SUFFOLK COUNTY PLANNING COMMISSION

Notice of Meeting

STAFF REPORT

Applicant: Bolla Edwards Avenue Reality LLC
Municipality: Riverhead
Location: Westerly side of Edwards Avenue, 2,645 feet southerly of Middle Country Road, in the hamlet of Calverton.

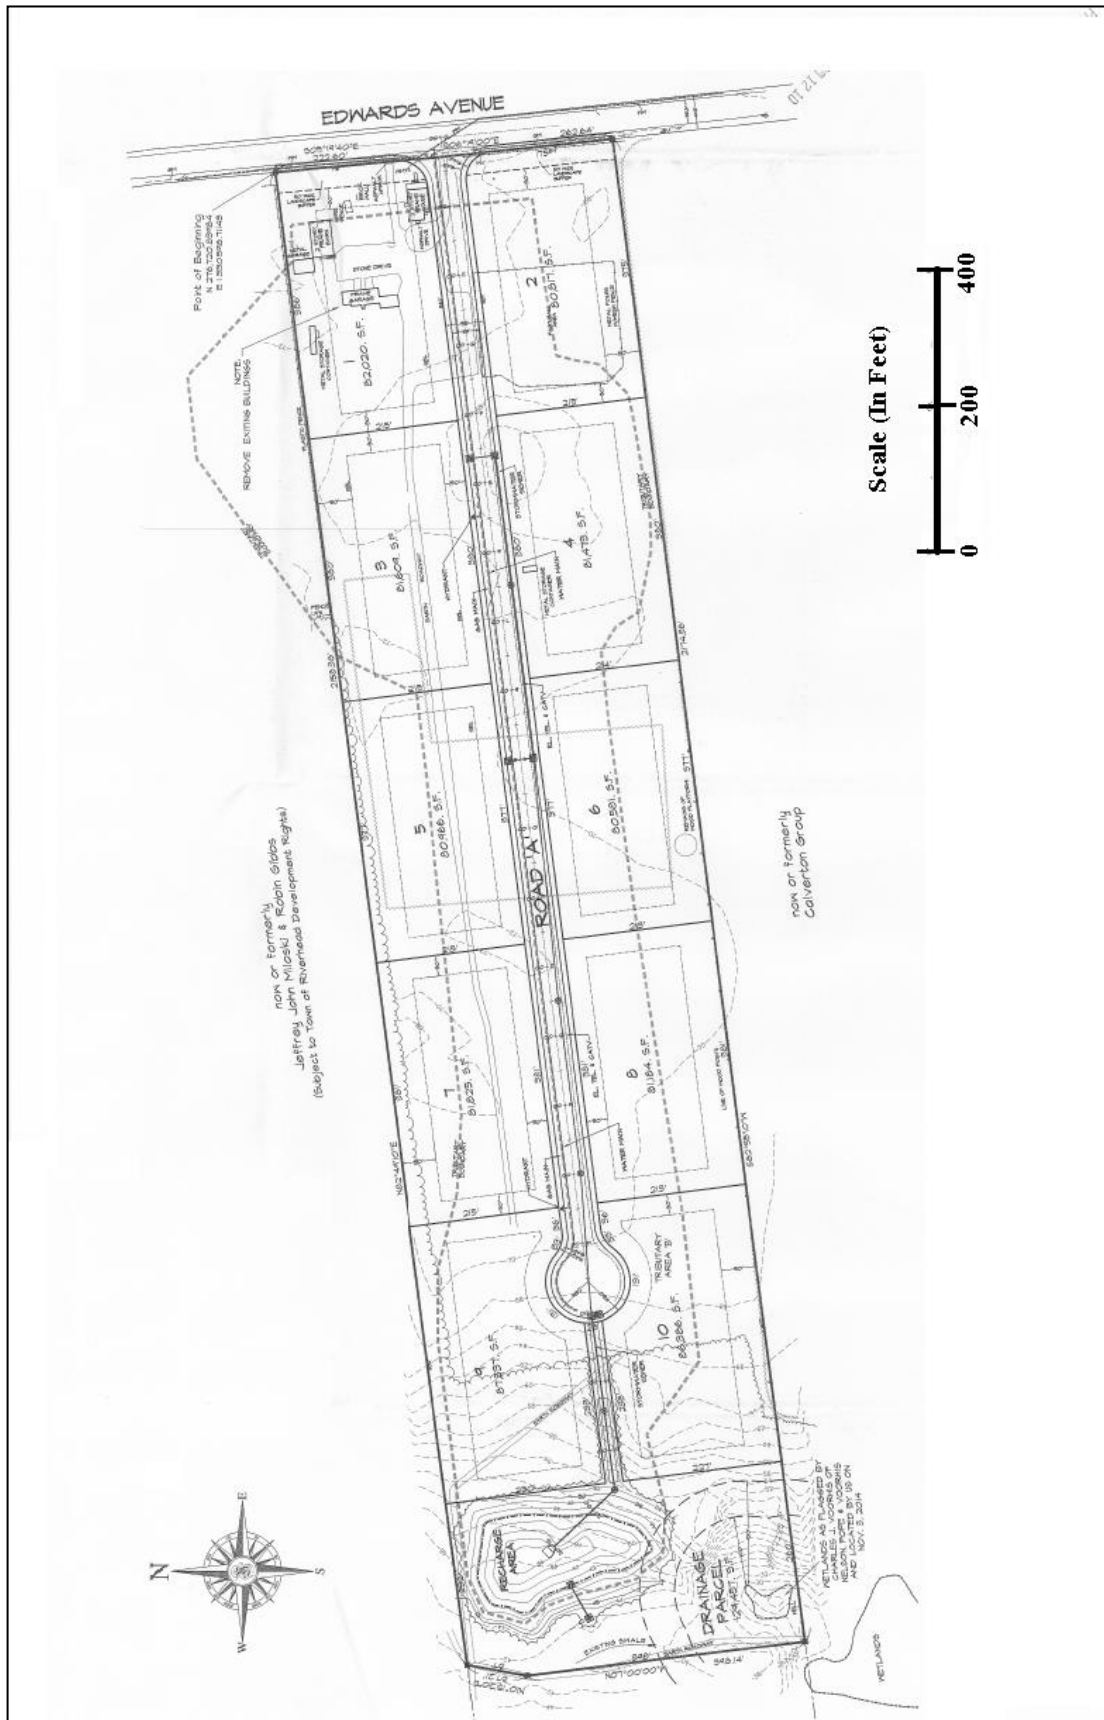
2. The long, straight road that is depicted in the proposed subdivision (proposed Road "A") could encourage speeding which would endanger all occupancies and users of the proposed subdivision, and result in public safety and other social and economic problems.

The Town should consider requiring the applicant to reconfigure the proposed subdivision cul-de-sac in a curvilinear fashion that would terminate along its southerly boundary. This would discourage speeding, making it safer for occupants and users of the subdivision, as well as contribute to a more visually pleasing streetscape.

Z-2: Huntington Station Gateway Plan
SCPD: HU-15-02
SCTM No: 0400-099.00-04.00-018.001 et al

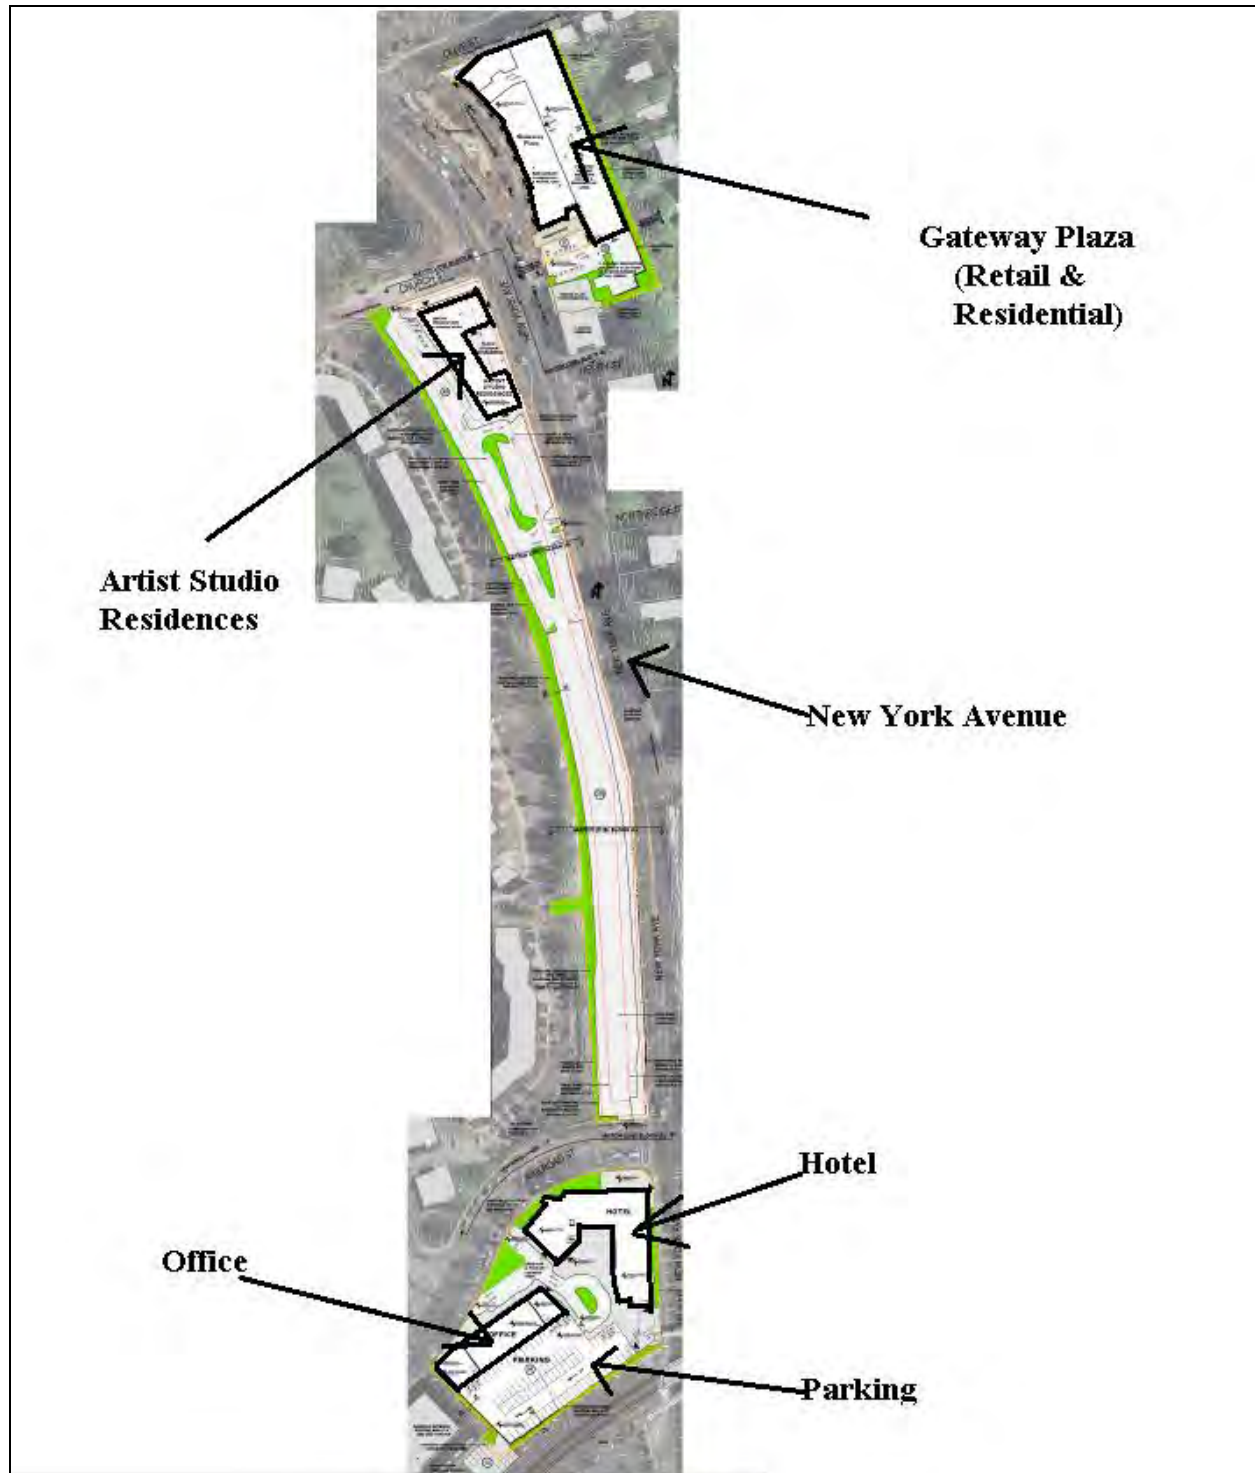
It is the belief of the staff that the applicant should provide a pedestrian circulation plan that provides a clear connection to the LIRR Huntington Station and Suffolk County Transit stops accounting for motor vehicle conflicts and pedestrian safety. The pedestrian circulation plan should also account for any proposed Bus Rapid Transit (BRT) location to be situated at the LIRR Huntington Station. Transit oriented development districts derive their viability from the multi-modal aspects of transportation provided by "TOD." Not demonstrating and implementing a pedestrian circulation plan highlighting walkability and connectivity to train, bus, BRT, bicycle, and other modes of transportation would be to ignore the intent of the Horizons 2020 Comprehensive Plan Update.

2. The petitioner shall provide a pedestrian circulation plan that provides a clear connection to the LIRR Huntington Station and Suffolk County Transit stops accounting for motor

vehicle conflicts and pedestrian safety. The pedestrian circulation plan should also account for any proposed Bus Rapid Transit (BRT) location to be situated at the LIRR Huntington Station.
